# **HORSESHOE ROAD**

## **Operable Unit 2 Superfund Site**

### **Value Engineering Study For U.S. Environmental Protection Agency, Region 2**

Final Report

Consolidate Wetlands, and Revise Grading to Reduce Backfill Requirements

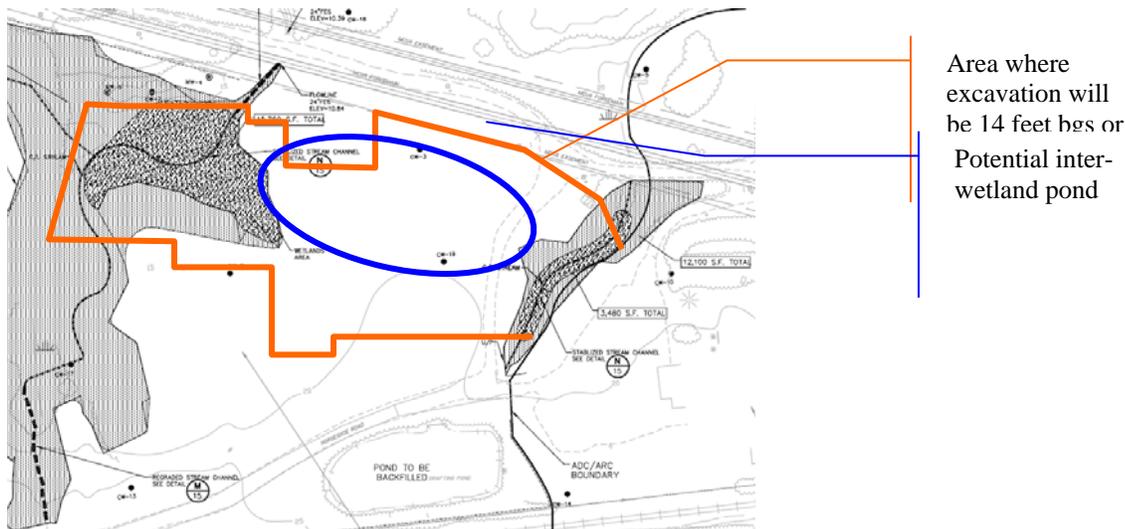
Consider filling the areas to be constructed as wetlands not to the grade level but to a deeper completion elevation as allowable (#40). The deeper completion may also allow for making the wetlands contiguous (#41). This could be done especially for the forested wetland on the far north extreme of the site and the larger forested wetland in grid F7 of drawing 13. The two forested wetlands could be connected by leaving a pond between the two thereby eliminating the need to place fill in the excavations to 14 and 16 feet below grade. This would provide contiguous habitat between wetlands as well as obviate the need for approximately 17,000 cubic yards or 28,000 tons of backfill.

The potential for saving \$1M is compelling. If it is possible to create an open water connection between wetlands without violating any wetlands construction regulations and if groundwater proves to be high enough to feed into such a feature, then the customer could consider this a viable option. See the conceptual drawing below.
